M.V. "CLYDEFIELD".

Existing Dimensions:- 420' x 57.5' x 32.75'

Proposed Dimensions:- 450.5' x 57.5' x 32.75'

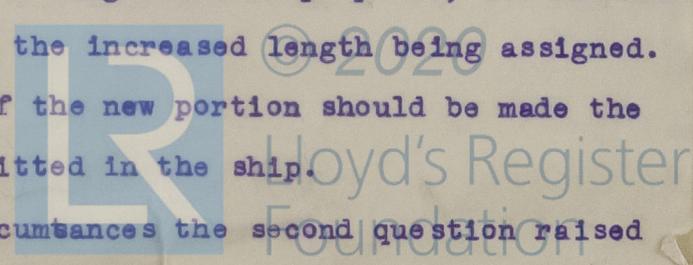
A letter has been received from Messrs. Cammell Laird & Co.Ltd., stating that the Owners are considering the possibility of lengthening the vessel by 30'-6". The additional length will be introduced between either Nos. 4 and 5 or Nos.5 and 6 tanks, the existing deck erections remaining unaltered.

The Builders desire to know the additional strengthening which will be required on account of these modifications, the minimum freeboard corresponding to the increased length being assigned. They also request to be informed of the minimum freeboard which could be assigned assuming no additional strengthening is fitted.

The scantlings and arrangements of the vessel as built have been examined, and it is found that in several respects, particularly the thickness of the deck plating and stringer, also the thickness of the longitudinal bulkhead plating, they are in excess of the Society's minimum requirements, and a section modulus calculation shews that the standard of longitudinal strength is equivalent to that represented by the practice of the Committee for the increased length.

It is submitted the Builders be informed accordingly, and that in the circumstances no additional strengthening will be required if the vessel be lengthened as proposed, the minimum freeboard corresponding to the increased length being assigned.

The scantlings of the new portion should be made the same as those originally fitted in the ship.

The addition to the length has the effect, however, of increasing the equipment number by one grade, and it will be necessary to increase the equipment on board to be ^{equivalent} ~~in~~ ~~accordance with~~ ^{to that required for} letter b† Table 53 of the Rules. If the proposal is to be proceeded with particulars shewing the Builders, or Owners, proposals in this respect should be submitted.

The increase in length will involve a reduction of about 6 inches in the existing draughts.
